Product Advisory (PA)

Subject: Correction to the Renesas Product ISL71840* Datasheet and DLA SMD

Change to ISL71840* Datasheet

Metalization Mask Layout

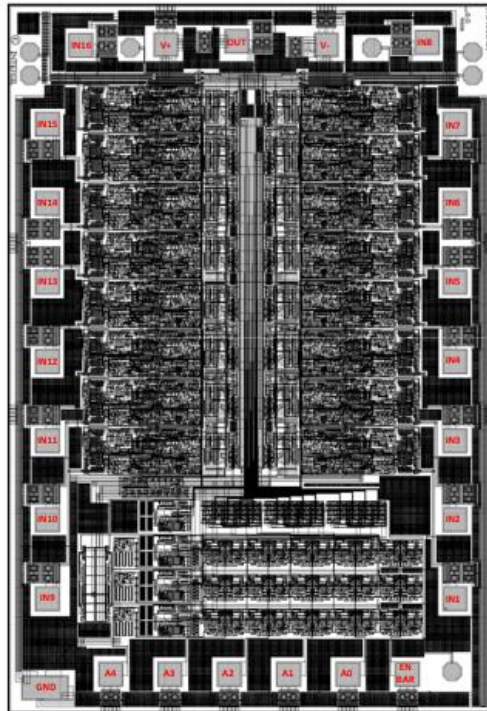
1. Update the Metallization Mask Layout diagram, correct label for pad number 18, from A4 to VREF. (Applies to both Datasheet and SMD)
2. Update "Table 3. ISL71840SEH Die Layout X-Y Coordinates". (Applies to Datasheet ONLY)
 - a. Row 2, Column 2: change from "V+" to "V-".
 - b. Row 4, Column 2: change from "V-" to "V+".
